**ADDENDUM #01**

Date of Addendum: December 15, 2020

SOUTH CAMPUS S1 PARKING GARAGE REPAIRS - ELECTRICAL SYSTEMS

207036 - South Campus S1 Parking Garage Repairs - Electrical Systems

ONE-LINE DIAGRAM NEW POWER RISER SCALE: NTS

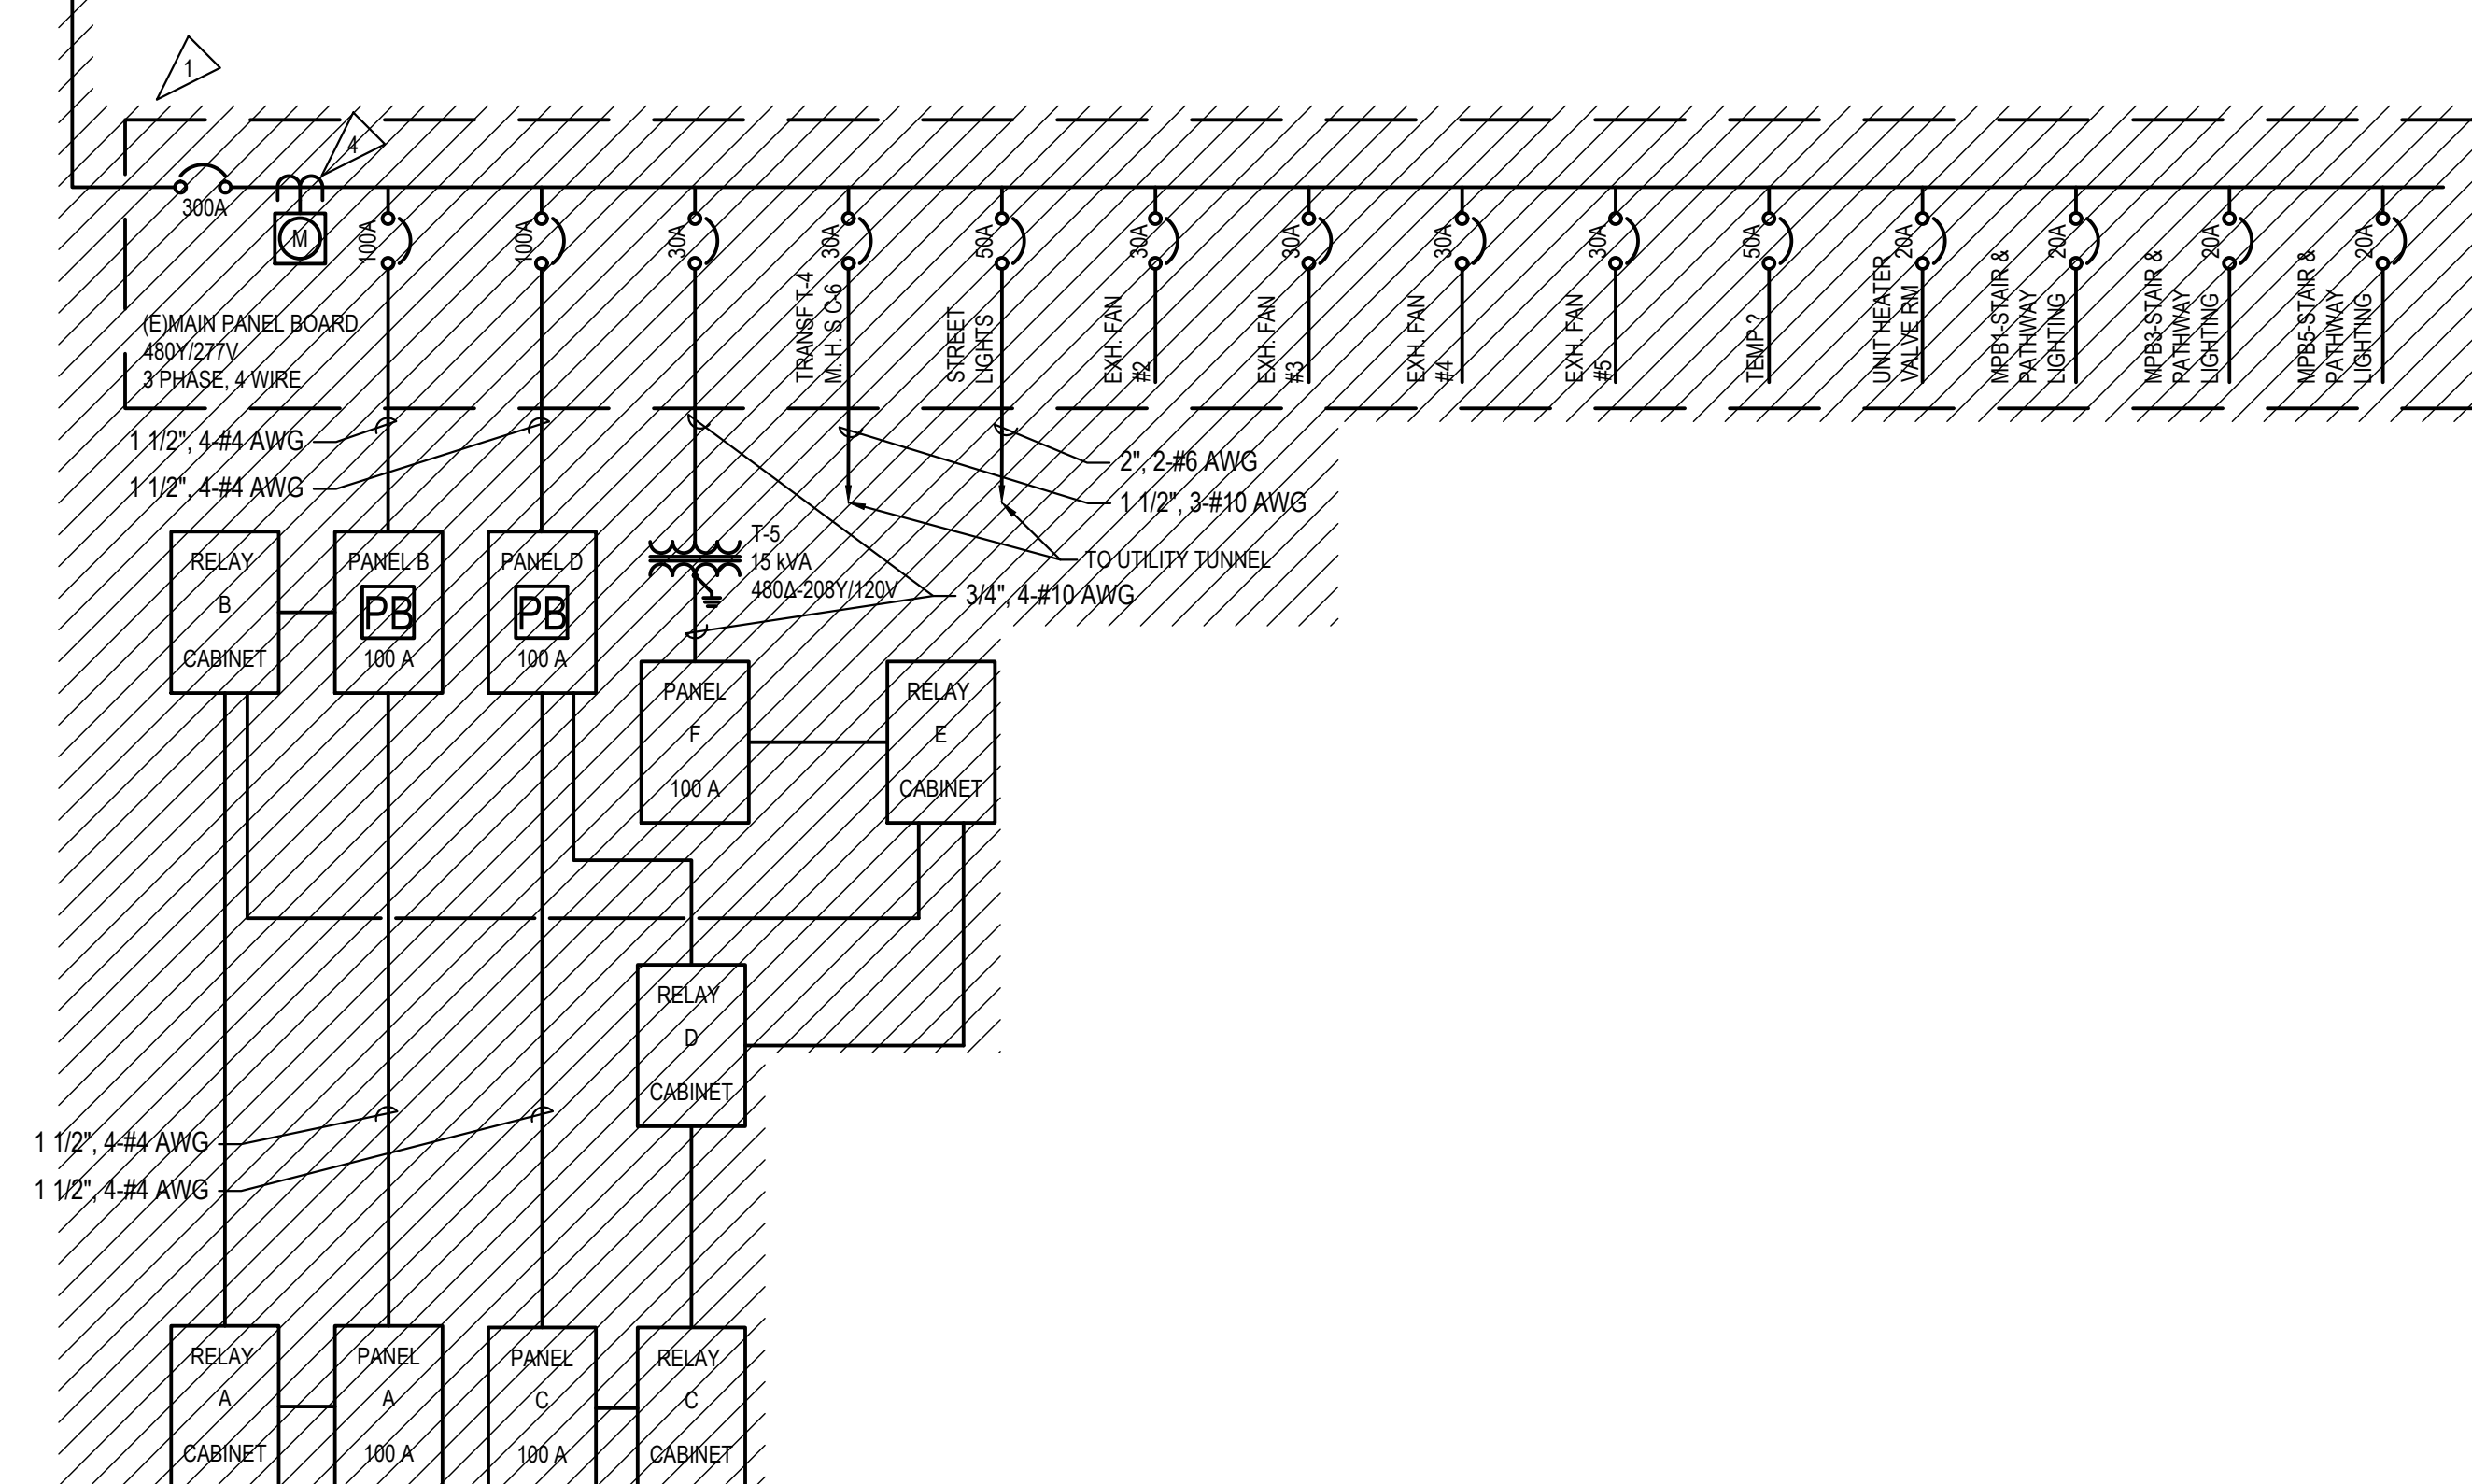
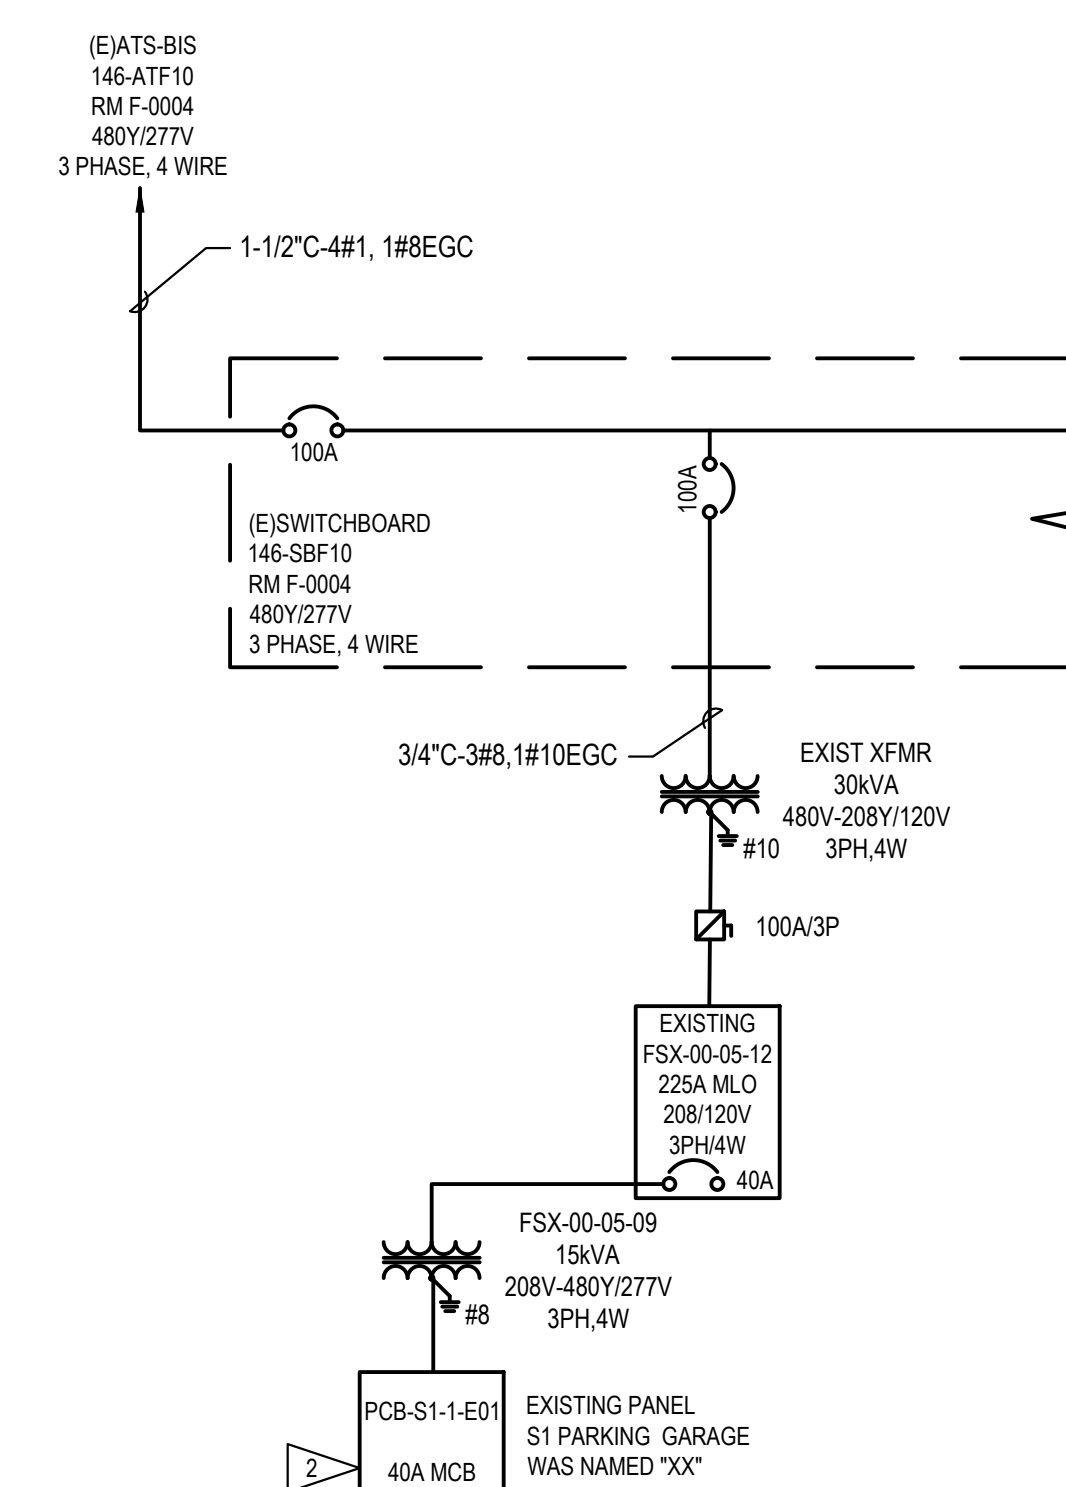
Item	Drawing No.	Description of Change
4.1	E6.00	Replace E6.0 to include the addition of requirement for testing of existing circuit breaker in switchboard 1226 SB1. See the revised E6.0 that is attached to this Addendum.

- 6. DEMOLISH THE EXISTING CONTACTORS AND WIRING.
- 7. PROVIDE TESTING OF THIS EXISTING CIRCUIT BREAKER PER SPECIFICATION SECTION 26 24 16. 3.4
